AMENDMENT TO THE DRAWINGS

Figure 1

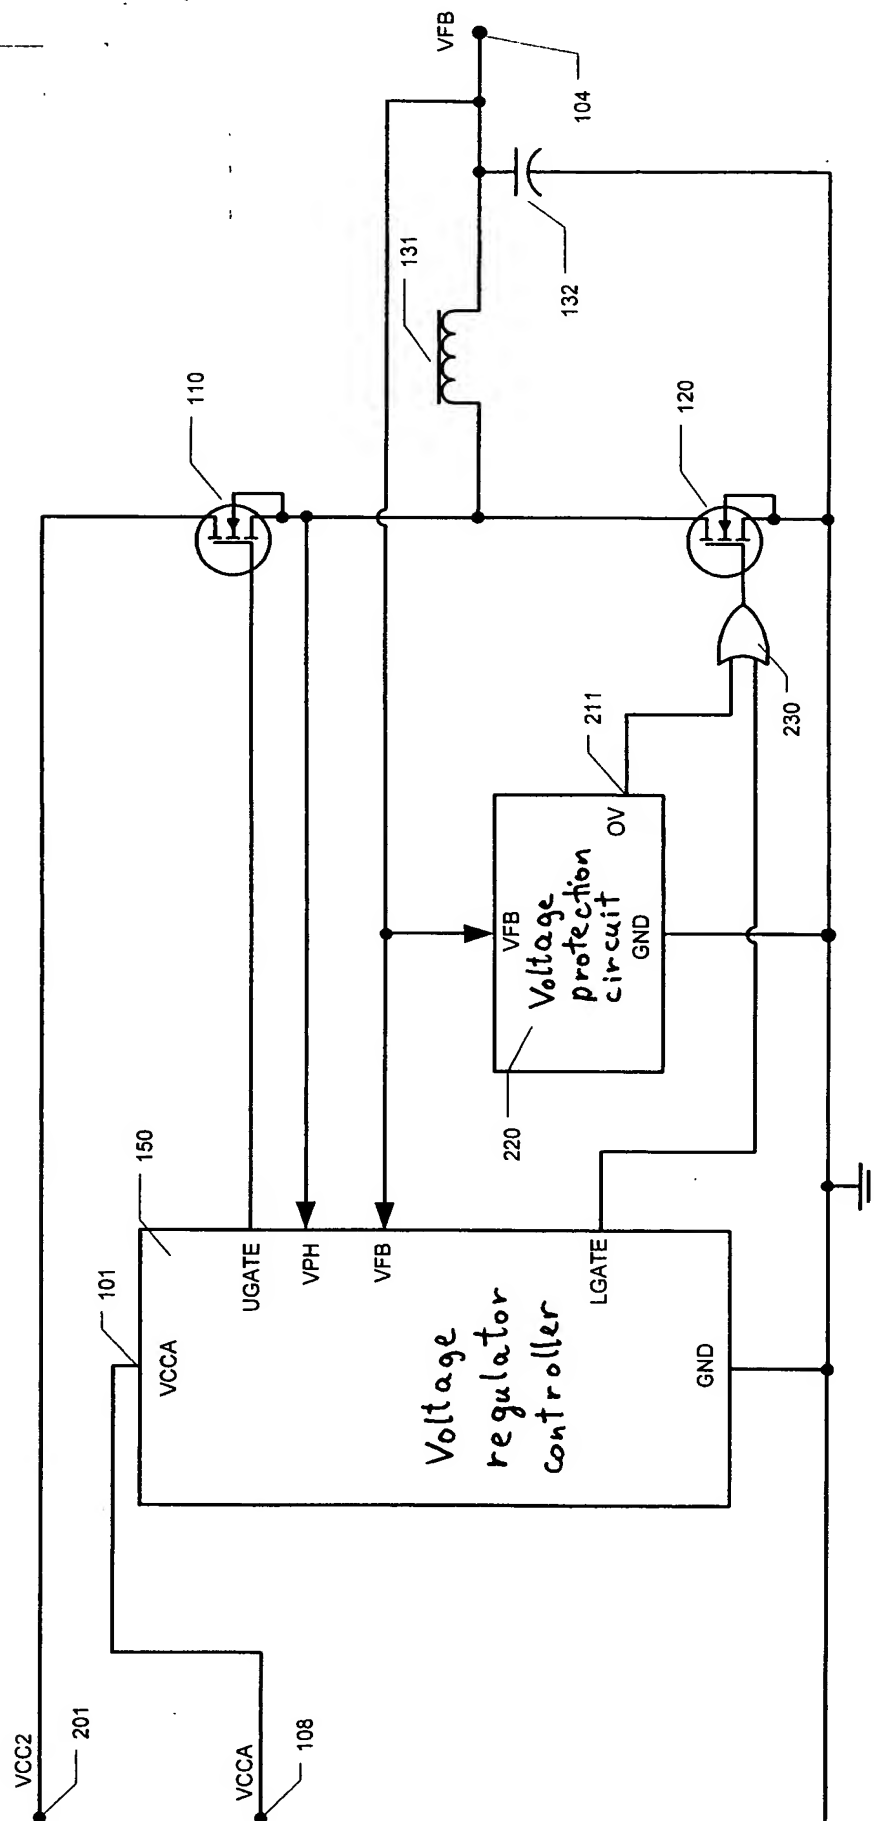
The drawings are objected to because at least FIGs. 1 and 4 should have descriptive labels identifying the different controllers. Descriptive labels have been inserted into FIGs. 1 and 4. Amended FIGs. 1 and 4 have been submitted with this Response.
